SUBJECT: REVIEW OF THE GESSAR II SSER 4

Attached for your review and concurrence is a copy of the proposed GESSAR II SSER 4. Copies of this version of the SSER were provided to the ACRS on June 28, 1985. Advance ACRS copies were necessary to allow the GESSAR II Subcommittee meetings to proceed in a timely manner. Your concurrence is needed by the close of business July 3, 1985.

SSER 2 and SSER 3 were issued in November 1984 and January 1985, respectively. They provide information related to the staff review of GESSAR II for severe-accident concerns. The present supplement (SSER 4) provides more recent information regarding resolution or update of the open and confirmatory items identified in SSER 3.

Figure 15.2 GESSAR II UPPS
Source: NEDE-30640

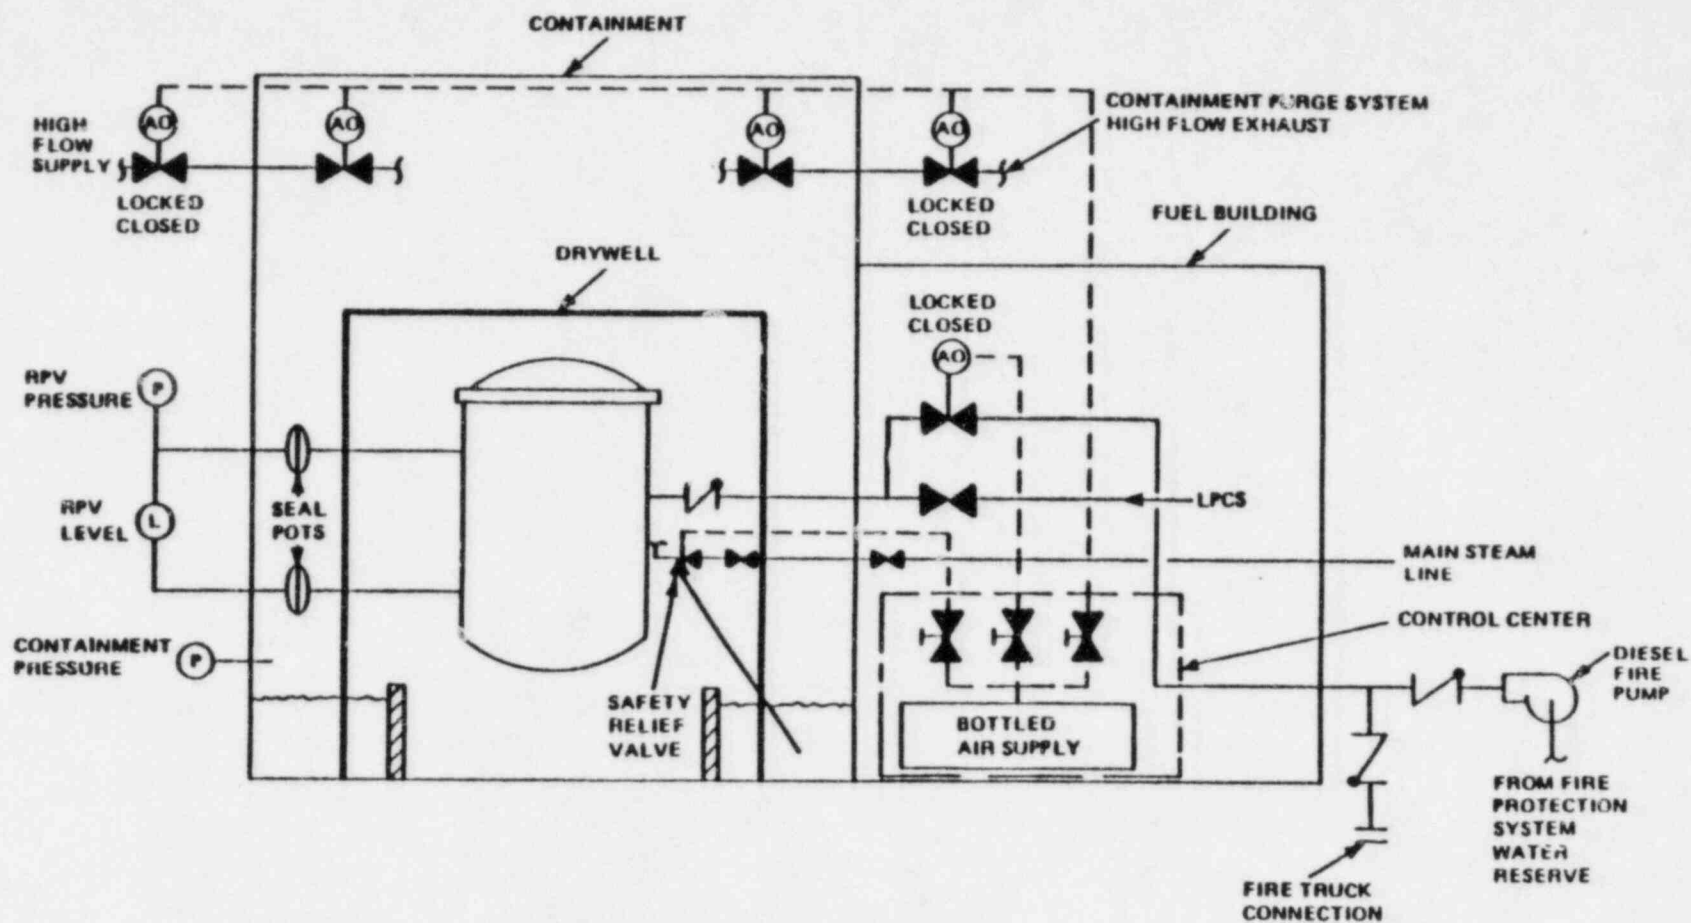
GE will provide detailed design information when an individual applicant references the GESSAR II design. Figure 15.2 shows a preliminary conceptual design of UPPS. The three primary functions of the UPPS are to (1) provide a reactor pressure vessel (RPV) makeup water supply capable of keeping the core covered, (2) provide RPV depressurization, and (3) provide containment heat removal. The system utilizes portions of the plant's emergency fire system, with modifications to allow for injection of water into the low-pressure core spray line. Dedicated air bottles will be used to provide motive power for air-operated injection valves, as well as operation of the safety/relief valves that must be used to depressurize the plant before injection from the low-pressure fire pumps. Air-operated containment vent valves will also be included to permit

After evaluating the potential design modifications, GE incorporated UPPS into the GESSAR II design. However, because of the preliminary nature of the design, the staff could not arrive at definitive assessments of the system's performance and capabilities. Conceptually the system offers significant advantages for responding to station blackout events, a class of accidents shown by the PRA to be a dominant contributor to core-melt frequency.

Although the UPPS system as proposed by GE has no seismic qualifications, the staff's PRA review indicated that seismic events dominate public risk. Without design details of the UPPS system, it was not possible to perform a detailed assessment of the system's seismic capabilities and response. However, the staff's contractor, BNL, in a draft report, "An Evaluation of Core Damage Reduction Benefits of Ultimate Plant Protection System" (Shiu and Reed, 1985), estimates the likely present seismic capability of the proposed UPPS. BNL modeled the core-melt reduction impact for upgrading the seismic capacity

From a defense-in-depth viewpoint, the staff also sees benefits to a seismically hardened UPPS even if the cost-benefit ratio is not shown to be attractive. The UPPS was proposed to be a final line of defense for the GESSAR II design. Very little plant equipment is required with this system to provide extended core cooling and containment heat removal. The staff evaluation of the GESSAR II PRA has shown that seismic core-melt risk exceeds the core-melt risk from internal events. Therefore, the proposed fall-back function of UPPS should show capabilities to respond to this class of event. However, the staff does affirm GE's design goal to maintain UPPS as a simple, manually initiated system of last resort.

The staff requires that GE provide details of how the modifications discussed in this section will be incorporated in the GESSAR II design. The staff requirements for these design improvements are conceptual in nature. In presenting the required detailed information on these systems, alternative designs may be proposed that offer equivalent functional performance. The staff requires that this information be submitted in sufficient time to complete its evaluation before issuing a construction permit or an operating license for a facility referencing the GESSAR II design. At this time, the staff does not believe that any design modifications in addition to those discussed and required above are warranted.
